Issue List

Jersey Mikes (Liberty, MO)

Project Issue Information

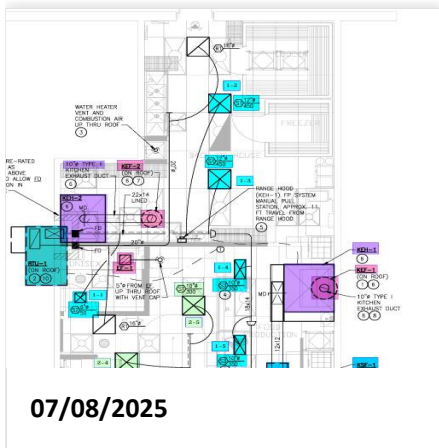
Issue Name : Diffuser 1-1 (Restroom) diffuser face loose
Description : Face of diffuser came loose during balancing. Temporarily secured with foil tape
Created By : National TAB **Assigned To :** National TAB - Kalen Kemp
Status : Open
Priority : Medium **Asset Tag :**
Originated Date : 07/08/2025 - Will Turnbough - National TAB
